Figure 2. Sequence Diagram: firmware update

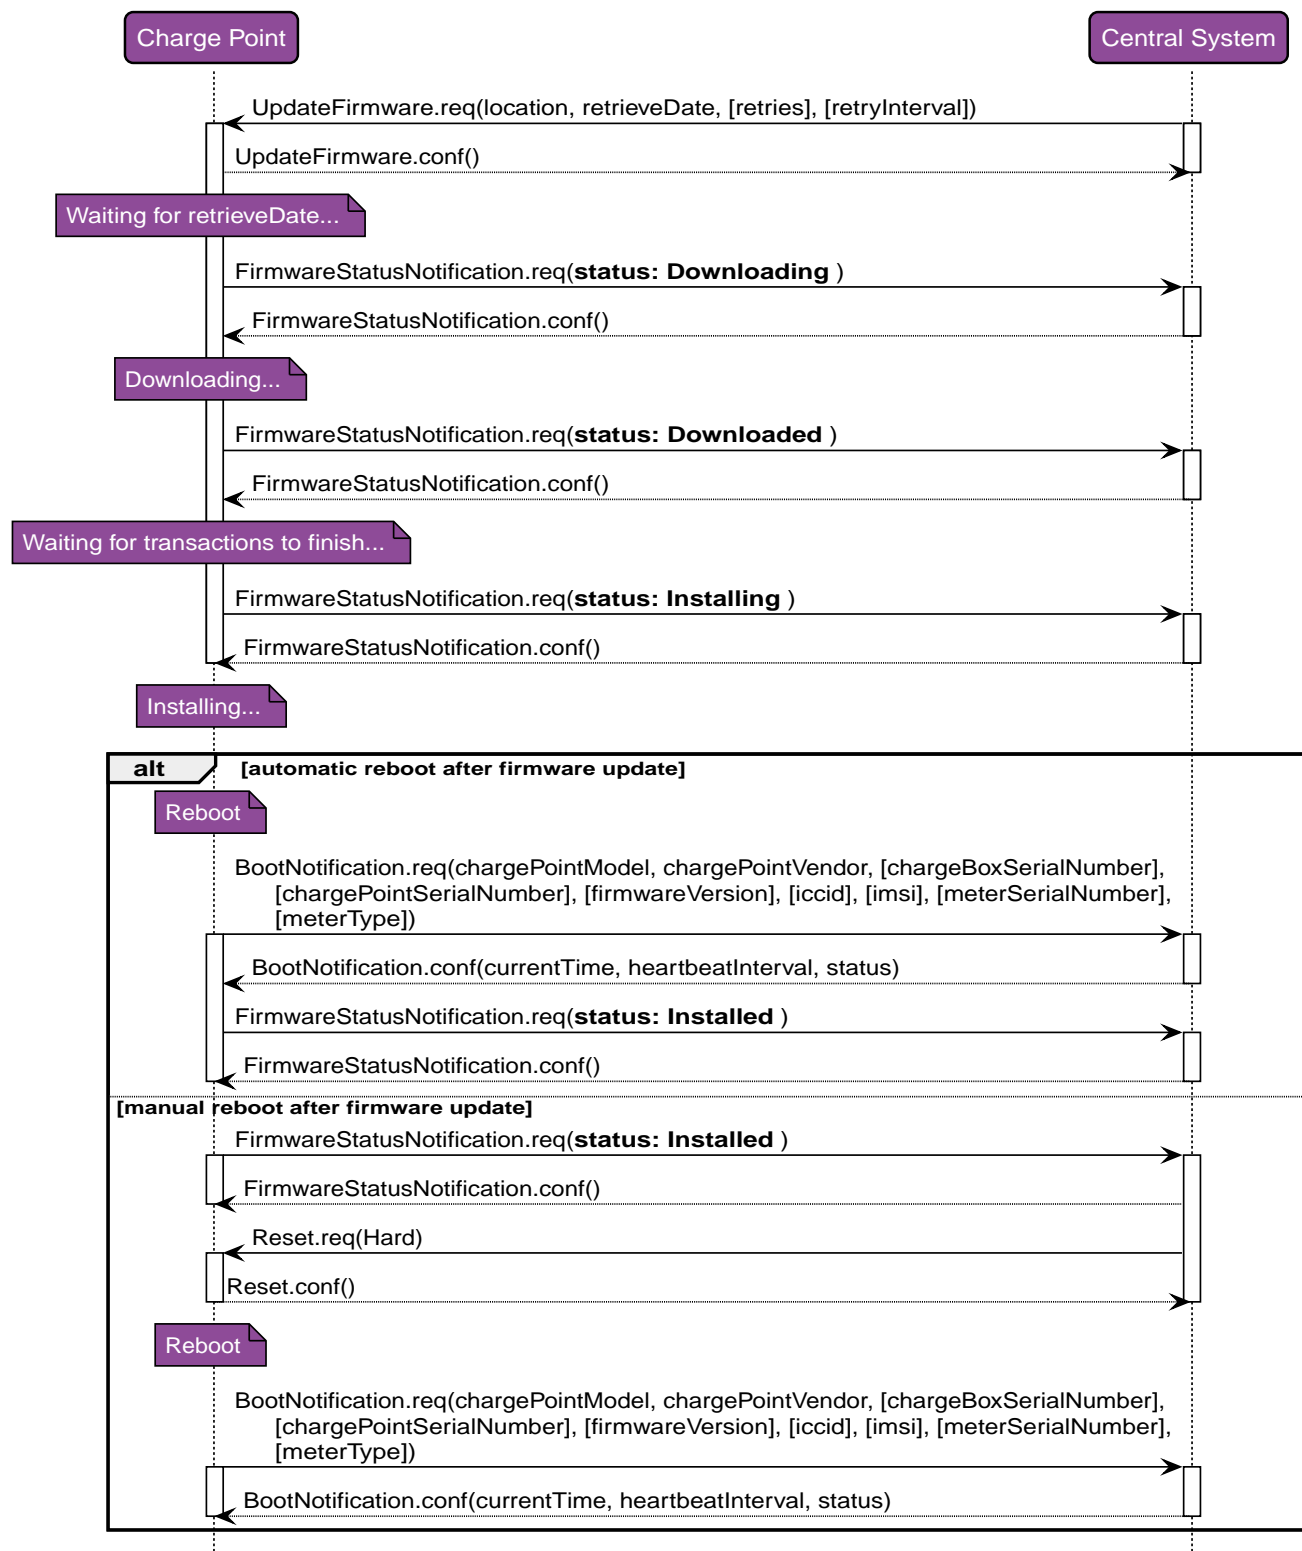
3.47. Page 61, section: 5.19: Relation between FirmwareUpdate.req and FirmwareStatusNotification.req is missing.

There is no description about the relation between FirmwareUpdate.req and FirmwareStatusNotification.req in the specification. In paragraph 3.3 on page 15, there is a more elaborate diagram of firmware update, including the relationship between UpdateFirmware.req and FirmwareStatusNotification.req, but that paragraph is informative.

The following diagram should replace the diagram in 5.19.

Additional text	<p>During downloading and installation of the firmware, the Charge Point MUST send FirmwareStatusNotification.req PDUs to keep the Central System updated with the status of the update process.</p> <p>The sequence diagram above is an example. It is good practice to first reboot the Charge Point to check the new firmware is booting and able to connect to the Central System, before sending the status: Installed. It is not a requirement.</p>
-----------------	--
